**Re: Lot 18 DP 270644, Greystanes Southern Employment Land (Boral Land)
Section 96 Application SSD_6801**

We provide this letter relating to a proposed Section 96 application to the Greystanes Southern Quarry West project approved under SSD_6801. Specifically this letter covers the civil engineering aspects of the amendment.

The Section 96 Application is for an amendment to the approved layout defined in SSD_6801. The main component of the amendment is for an adjustment to the approved masterplan lot layout and minor changes to warehouse levels in Precincts A and B.

SITE MASTERPLAN
SCALE 1:1500

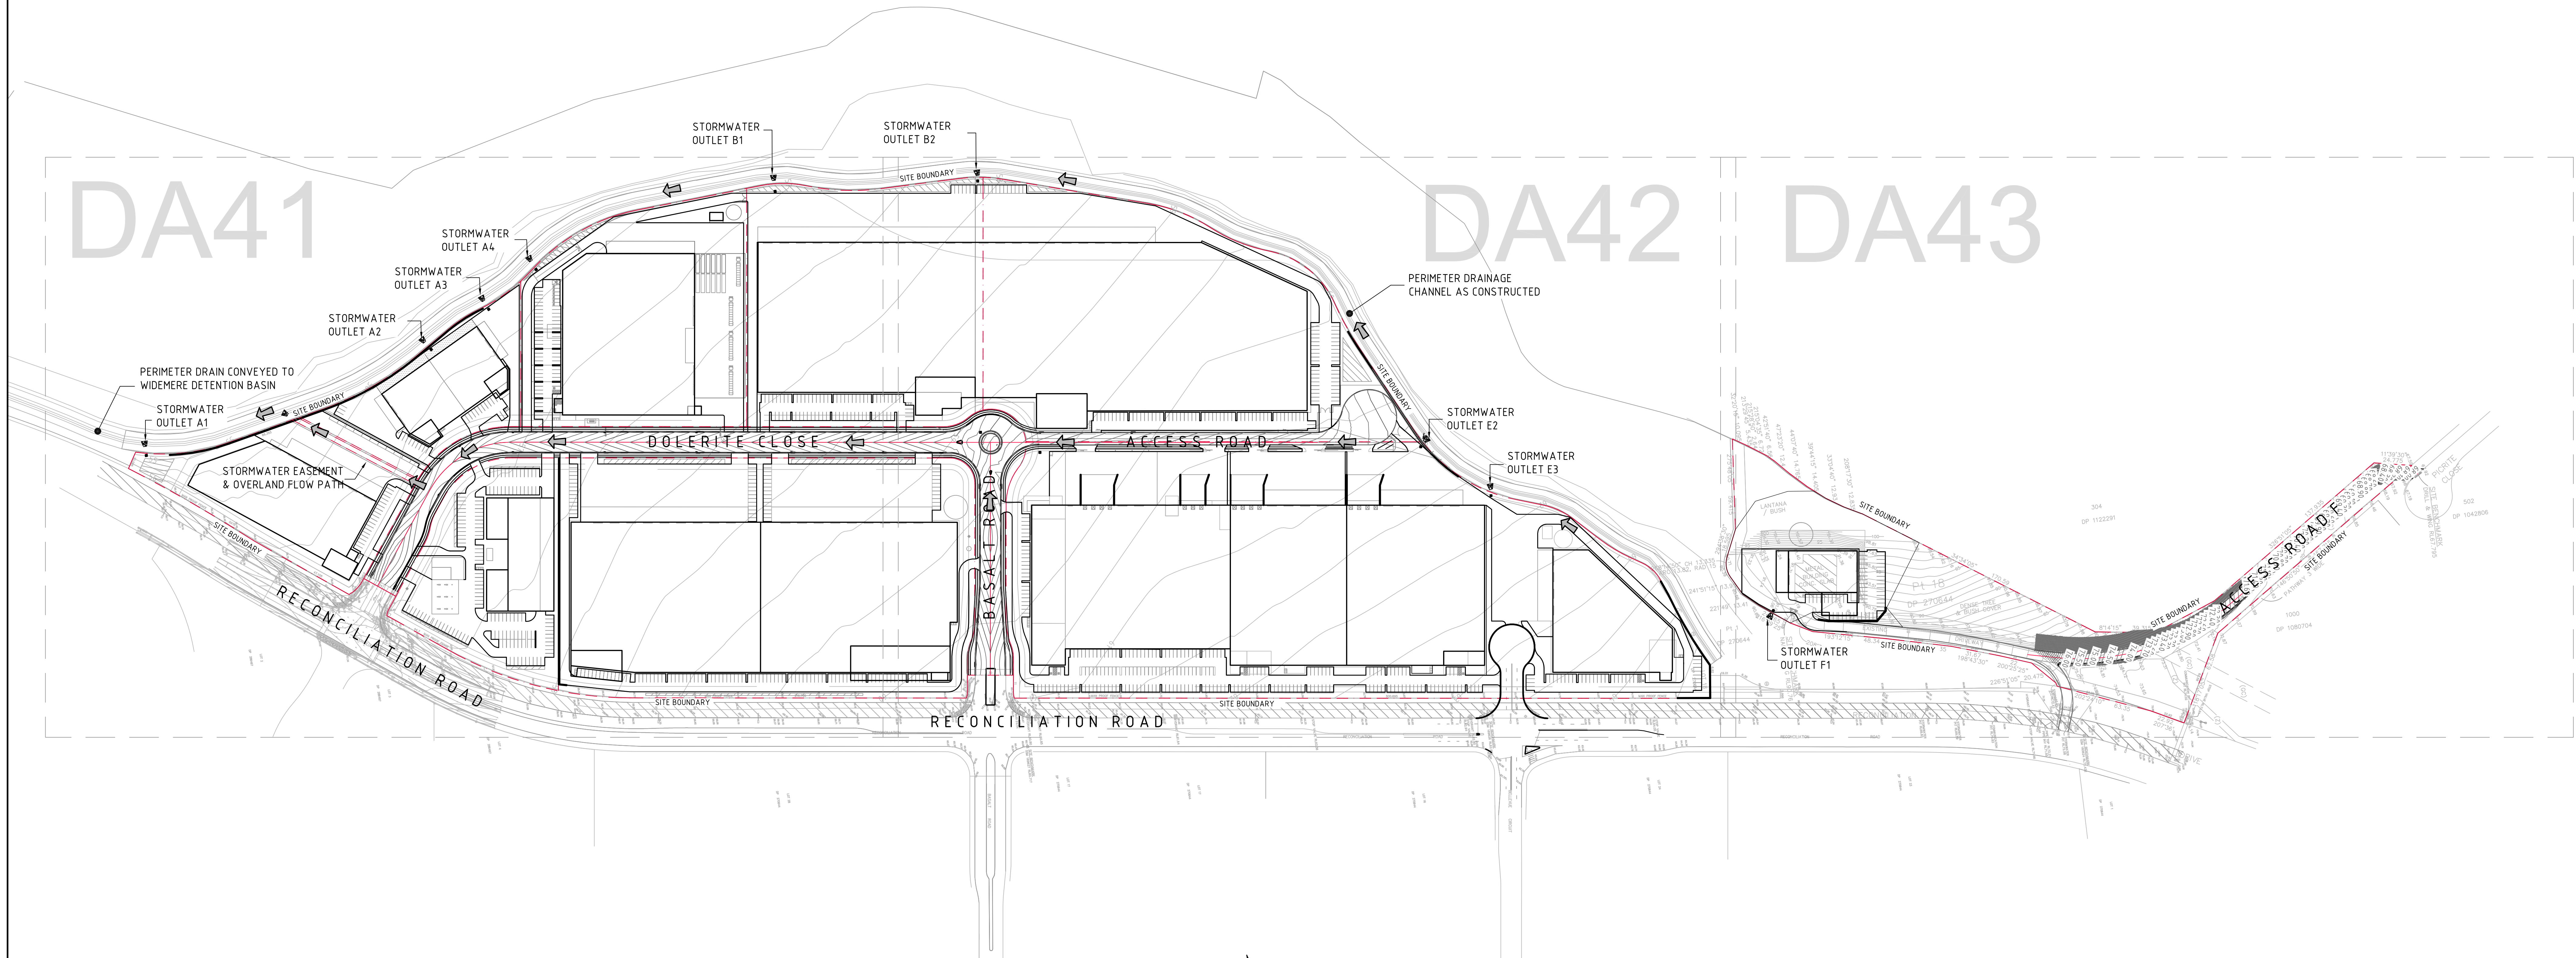
The development layout differs from the previous submission in that the arrangement of the development lots on the northern side of Dolorite Close within Precincts A and B have been adjusted.

The adjustments mainly relate to Warehouse B1 and Warehouse A2. The lot layouts to the east and south of the estate road are generally consistent with the approved SSD_6801. Some minor changes to car park arrangement to the north of Warehouse B2 have also been made.

The floor levels for warehouse B1 and B2 have had some minor adjustments to suit a balance of cut to fill earthworks and to better facilitate access to the development sites.

Warehouse B1 floor level has been lowered from 59.3 to 59.00m while Warehouse B2 has been raised from 59.30 to 59.90m.

Minor adjustments to the locations of the bio-retentions within the site have been made. The basin to the north of Warehouse B2 & Warehouse B3 has been adjusted as a result of the carpark arrangement specified above. It can be confirmed that the minimum required 3000m² of bio retention, as defined in SSD_6801, has been provided.

Additionally an extra stormwater outlet pipe and stub has been provided to the north of Warehouse B1. This is the result of the adjusted development layout and boundary location specified above. The majority of the approved drainage outlets have now been constructed, therefore an additional outlet pipe is required to facilitate drainage of Warehouse B1 without the need for easements within adjoining lots. This change does not affect the ability for the western drainage swale to convey the required 1 in 100 year ARI design storm.
